PALMERSTON NORTH CITY COUNCIL

HEARING BY COMMISSIONER

9.30AM, TUESDAY 7 MARCH 2023

1. Hearing of an Objection from Woodgate Limited, under section 357 of the RMA in relation to a decision by the Palmerston North City Council under section 88(3) of the RMA that resource consent application RC LU6923 was incomplete.

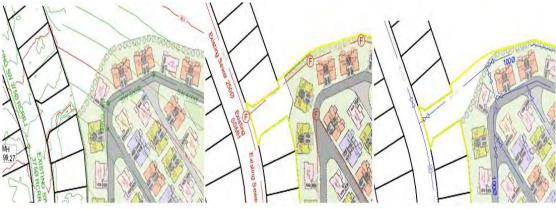
This will discharge to Johnson Gully to the north and has been sized to accommodate conveyance of stormwater from the adjacent residential area to the southeast, as well as the proposed development. The pipe will connect to the Council pipe with a 450 mm diameter and will then increase in stages as lateral pipes connect from within the site. At the site exit the pipe size is expected to be 750 mm as shown on Drawing 2043-220.

- 4. It appears that this development is reliant on the consent being issued for the construction of a gully crossing and stormwater detention dam to the north of the site (application LU6299) referenced in pages 32 and 33 of the application. Consent application LU6299 is yet to be processed and so there is no certainty that this can be relied on for the proposed stormwater solution. Please address the interrelatedness of this application in more detail and what alternatives there are to managing stormwater from the proposed development.
- 5. The application assumes a development agreement will be formalised with Council is the following statement on Page 11 of the application:

Proposed residential subdivision scheme plan (SUB 6938)

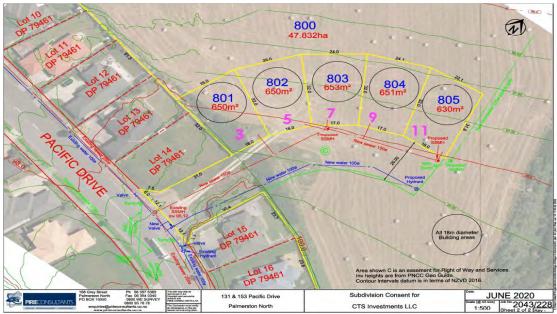
- 10. Please provide right of way design details for proposed right of way easement B on Scheme Plan 2043-299 Sheet 2 of 2 dated June 2022.
- 11. Please clearly confirm the name of the applicant as there are several references to CTS Investments LLC within the application.
